UNITED STATES PATENT AND TRADEMARK OFFICE

APPLICATION NO.	FILING DATE	FIRST NAMED INVENTOR	ATTORNEY DOCKET NO.	CONFIRMATION NO.
10/729,839	12/06/2003	Kurt Hoffmann	ZIMR/0006	8307

Office Action Summary

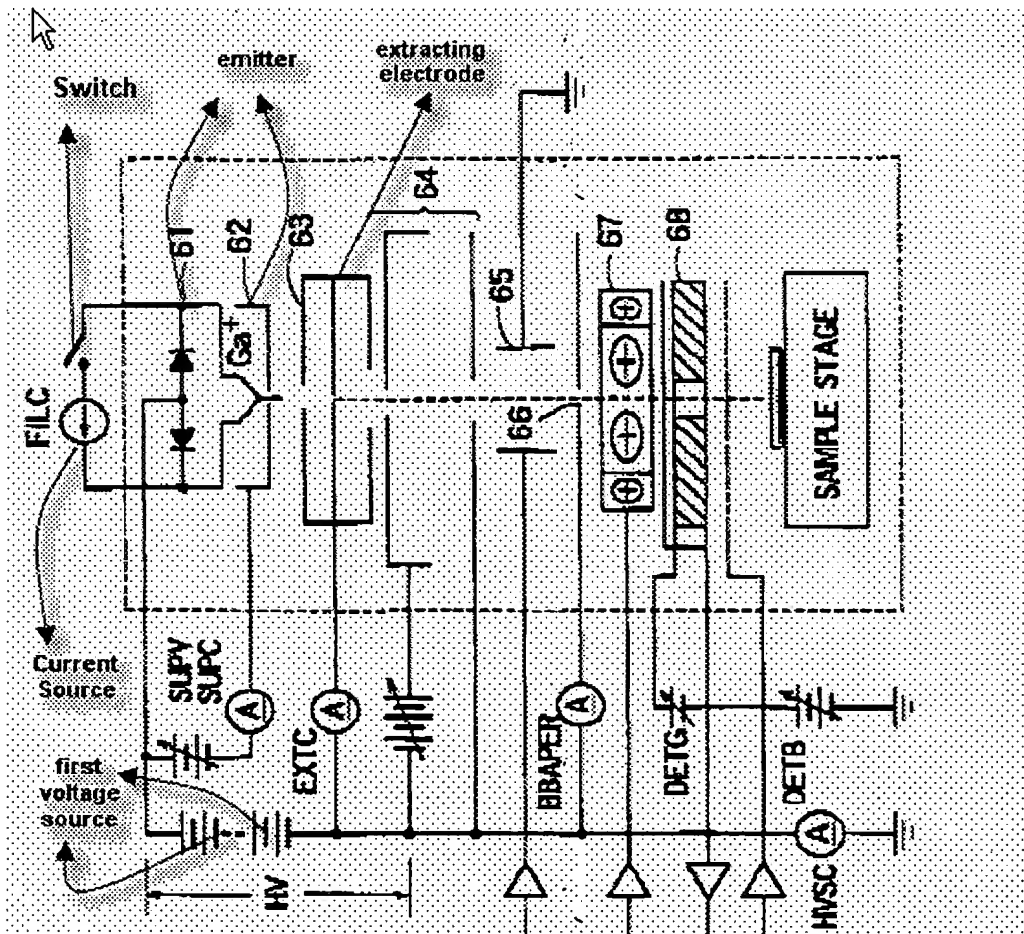
Claims 1, 26, 27 are rejected under 35 U.S.C. 102(e) as being anticipated by Ito et al. (6,372,612).

Regarding Claim 1, Ito discloses a field emitter beam source (See above or figure 7) comprising:

- an emitter (61, 62);

- an extracting electrode (63) to extract a beam current from the emitter (61, 62);
- a first voltage source (batteries connected between 61 and 63) for providing a first voltage between the emitter (61, 62) and the extracting electrode (63) to switch on the beam current;
- a current source (FILC) for providing a predetermined beam current;
- the current source being coupled to the first voltage source; and
- a first switch (switch which is connected on the right side of the current source) for disconnecting the first voltage source from the current source.
